LINCOLN PROFESSIONAL PARK FILING NO. 1 - LOT 2
CONSTRUCTION DOCUMENTS

TOWN OF PARKER PLAN REVIEW
20120 E MAINSTREET
PARKER, 80138
PH: (303)805-3174

SHEET
296237001_CV-CDS
C1.0

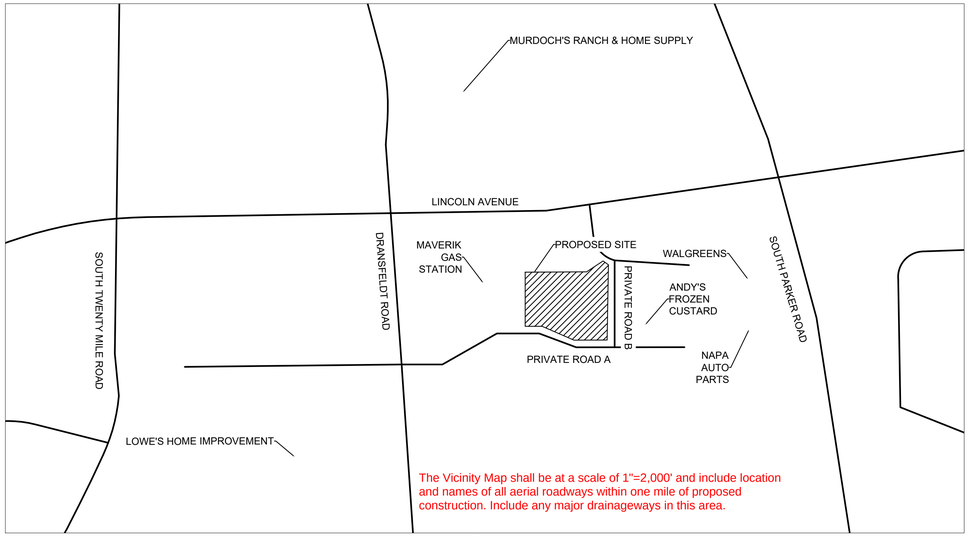
Please add Town of Parker Engineering/Public Works (303) 840-9546

Please provide on the cover sheet a table of the volume of cut, volume of fill, volume of material to be exported offsite, the steepest proposed slopes, the total area of land disturbance, the existing impervious area, the proposed impervious area (total impervious area for the site) and the area of land disturbance treated by a water quality control measure per the SDECM.

STORM PLAN - STA. 0+00 TO 2+57

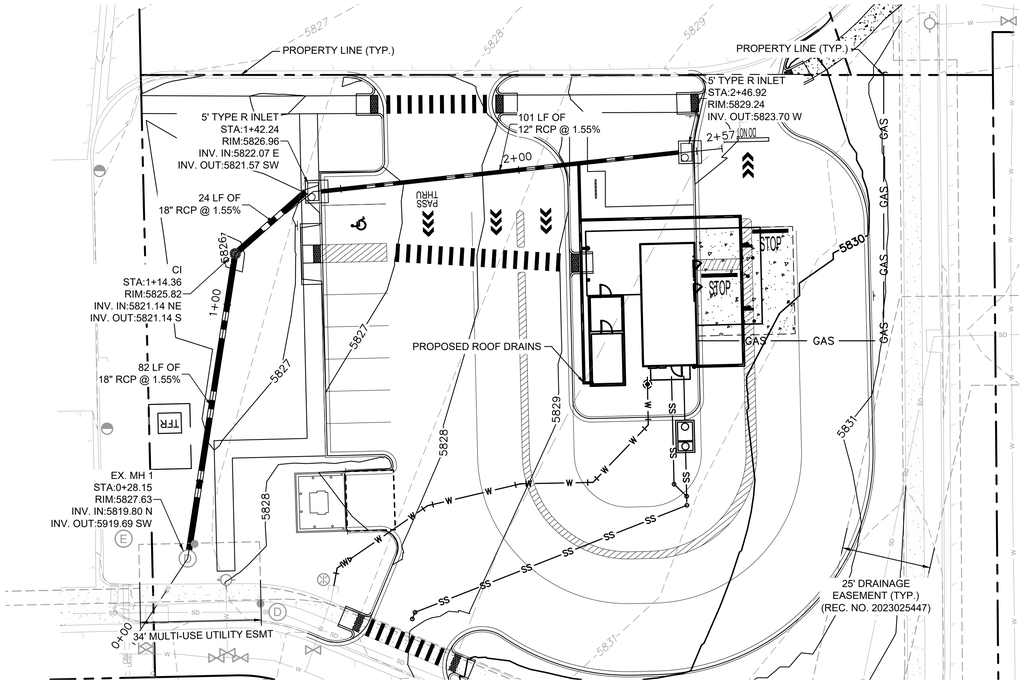
Please be aware that the Town does not allow storm main line connection to plastic nyloplast area drains, these private systems must connect to the public storm sewer system at a standard inlet or manhole structure (Concrete manhole or Type C Inlet). Please reference and provide the detail for the area drain.

STORM PROFILE - STA. 0+00 TO 2+57

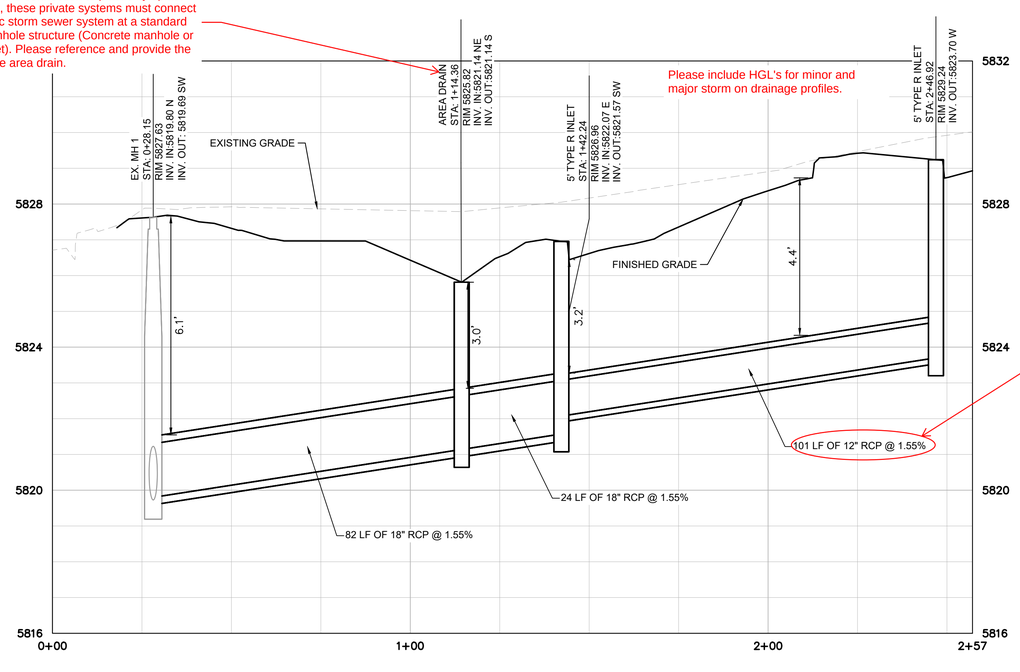
Please include HGL's for minor and major storm on drainage profiles.
